Access Compliance Report Public Rights-of-Way (Curb Ramps)

Intersection ID: 10036977 Main Street: S_TRYON_ST Cross Street: N/A Location: Ramp Type: Directional1 **Overall Compliance: No** ADA ID: A6F75652A198 Initial Pass/Fail: Fail **Severity Score:** 1.25

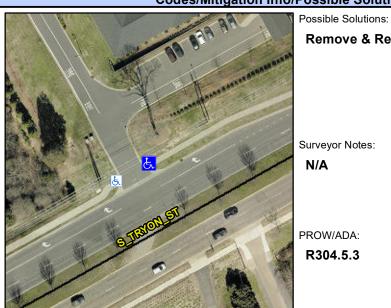
Field Measurements/Component Compliance							
Compli	ance Description	Data	Comp	liance Description	Data		
N/A	Ramp Length (in)	80.0	N/A	Grade Break?	N/A		
Yes	Ramp Width (in)	69.0	N/A	Grade Break Slope (%)	0.0		
Yes	Ramp Slope (%)	3.8	N/A	Grade Break XSlope (%)	0.0		
No	Ramp XSlope (%)	2.9					
N/A	Flare Type LT	N/A	N/A	Flare Type RT	N/A		
N/A	Flare Slope LT (%)	N/A	N/A	Flare Slope RT (%)	0.0		
N/A	Flare Traversable LT?	N/A	N/A	Flare Traversable RT?	N/A		
N/A	Landing Length (in)	0.0	N/A	DWS Provided?	N/A		
N/A	Landing Width (in)	0.0	N/A	DWS Contrast?	N/A		
N/A	Landing Slope (%)	0.0	N/A	DWS Length (in)	N/A		
N/A	Landing X Slope (%)	0.0	N/A	DWS Full Width?	N/A		
N/A	Landing Curb? (Y/N)	N/A	N/A	DWS Offset LT (in)	N/A		
N/A	Shared Landing?	N/A	N/A	DWS Offset RT (in)	N/A		
N/A	Gutter Ponding?	0.0	N/A	Gutter Slope (%)	N/A		
N/A	Gutter Lip Ht (in)	0.0	N/A	Gutter X Slope (%)	N/A		
N/A	Painted X Walk1?	No		Road Slope (%)	3.5

Remove & Replace Entire Ramp. Surveyor Notes: N/A PROW/ADA: R304.5.3
